<b>ADDENDUM TO THE CONTRACT DOCUMENTS</b>	<b>Page Number</b> 1	<b>No. of Pages</b> 35
<b>Addendum No. Three</b>	<b>Date Addendum Issued:</b> April 19, 2019	
<b>Issuing Office</b> Department of Natural Resources Support Services Division Procurement Section 550 West 7 <sup>th</sup> Ave., Suite 1330, Anchorage, Alaska 99501 Phone: 269-8666 Fax: 269-8909	<b>Previous Addenda Issued</b>  One and Two	
<b>Project:</b> Kodiak Habitat Enhancement Project Lake Catherine Area <b>Project No.:</b> ITB 10-005-19	<b>Date and Hour of Quotes Due</b> April 25, 2019 at 2:00 PM. (UNCHANGED)

1. Lake Catherine drawings, Sheet C-115, replace in its entirety with the attached Sheet C-115 Rev 1.
2. ADF&G Fish Habitat Permit, the ADNR Water Use Permit, SHPO approval, and COE approval are being provided with this Addendum.

PROJECT KODIAK ISLAND HABITAT ENHANCEMENT PROJECT  
(FISH PASSAGE); BID PACKAGE 3  
LOCATION KODIAK, ALASKA  
CLIENT U.S. FISH & WILDLIFE SERVICE (FWS)

DRAWING CULVERT 20700877 GUARDRAIL PLAN & ELEVATION

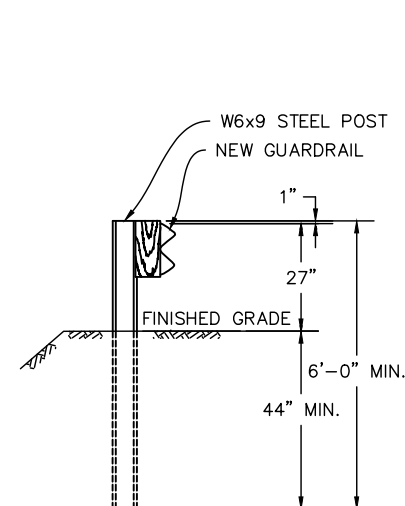
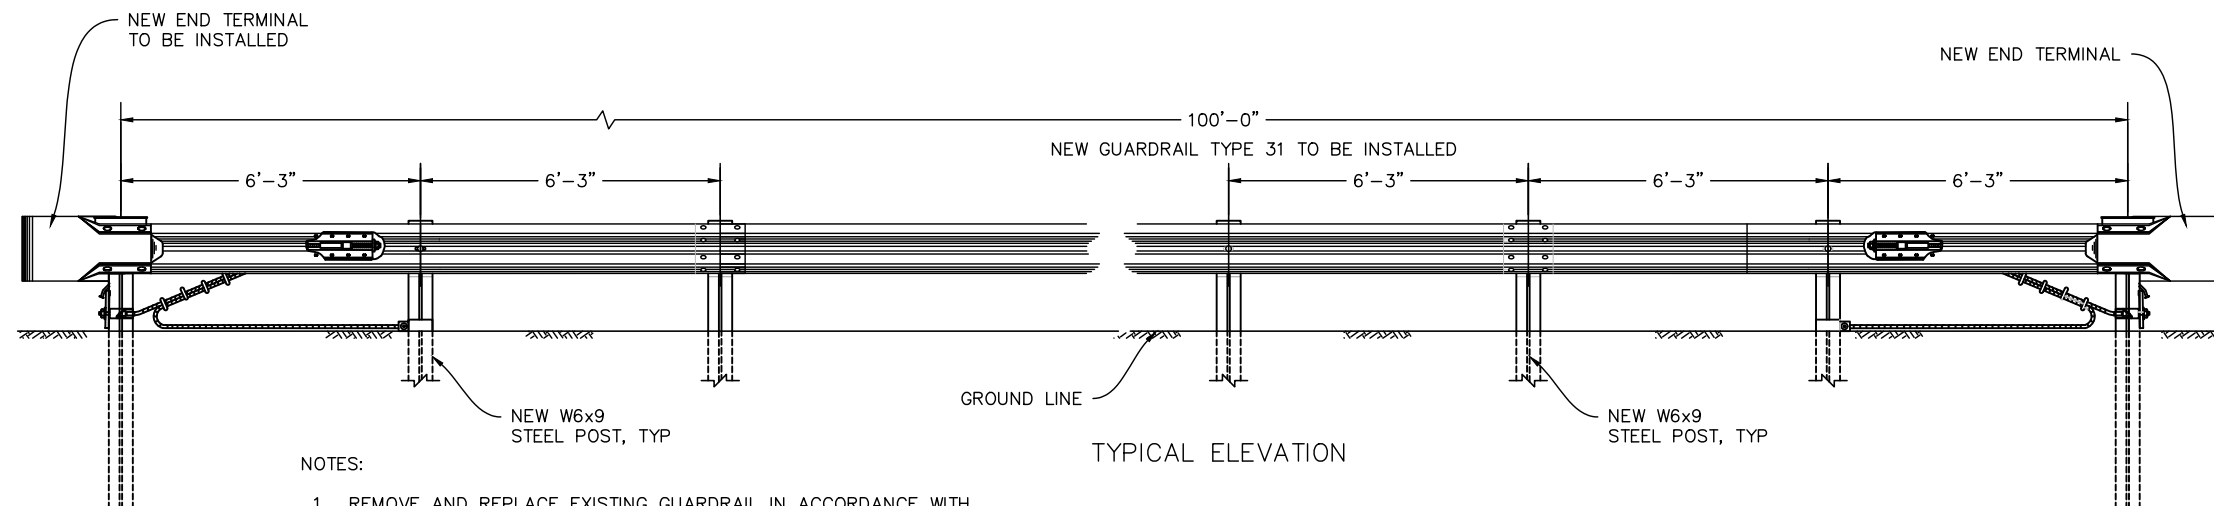
8. Section 606 Guardrail – Is the intent to reuse the existing end terminals? I don't believe they'd meet current standards. ***The Contractor shall replace all existing guardrail in the project area. See revised plan sheet C-115 attached to this addendum.***

9. Section 606 Guardrail – Is the intent to reuse the existing W-Beam Rail and Posts? They've been damaged and are rusty in areas. ***The Contractor shall replace all existing guardrail in the project area. See revised plan sheet C-115 attached to this addendum.***

19. Has a SHPO Permit been acquired for this project? ***Yes. See attached.***
20. When Ditches are realigned, is this work subsidiary? ***This work is incidental to the pay item.***
21. Section 606 Guardrail – I got some more info from our Guardrail Sub. The existing end treatments are a NCHRP 230 (BCT) Breakaway Cable Terminal and they have not been used since 1998, parts are not available, and likely are supported underground in a steel drum full of concrete. The existing guardrail will have to get new spacing blocks, new hardware, and some of the rail is bent up and needing replacement. It's likely some of the steel posts will need replacement as well depending on if they were bent on original installation. We suggest replacing the entire system with new rail, steel posts, composite block outs, and

NCHRP 350 End Terminals for the oncoming traffic ends and beaver tails for trailing ends. ***The Contractor shall replace all existing guardrail in the project area. See revised plan sheet C-115 attached to this addendum.***

**A DIVERSION PLAN**  
SCALE: 1 : 20

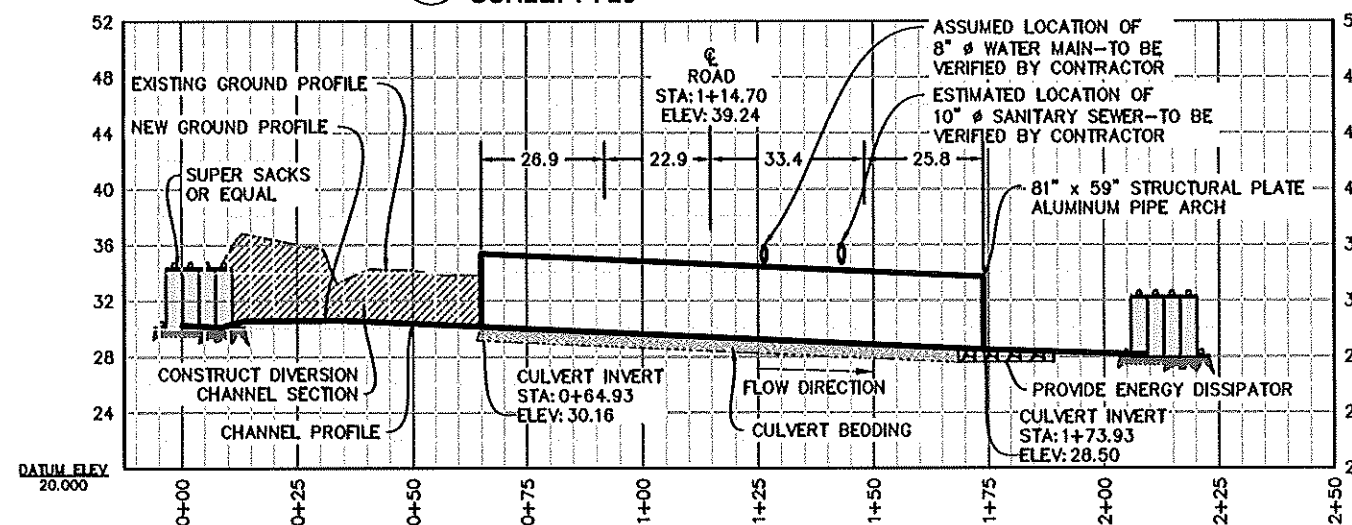
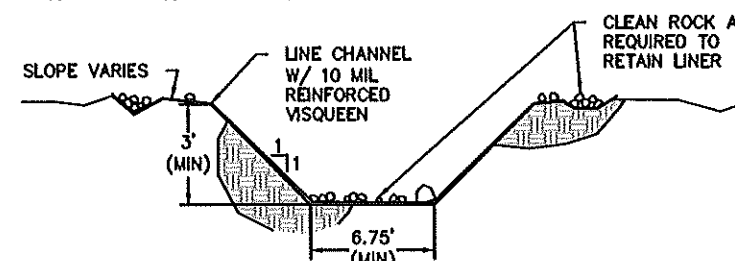
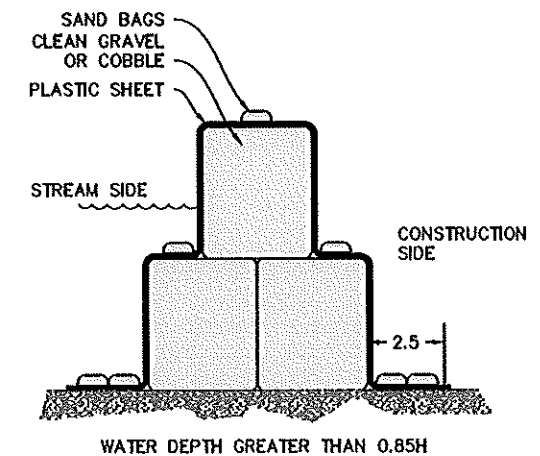
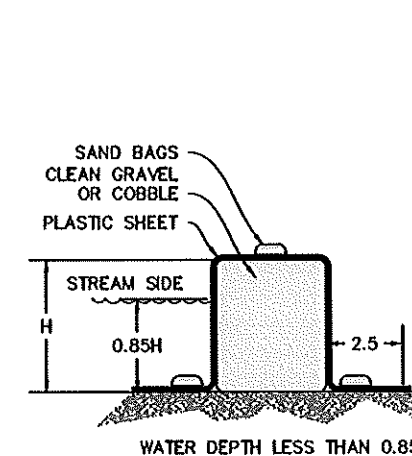
5. Sheet C-101 of the plans, note 6 states the supersacks shall be waterproof. Is normal supersack material sufficient as long as it meets the lifting standard in the same note, and a water proof sheeting is placed over

the top of the supersacks? ***Please see the plan detail referenced on Sheet C-101. The objective is to create a waterproof barrier to prevent water seepage into the area of construction.***
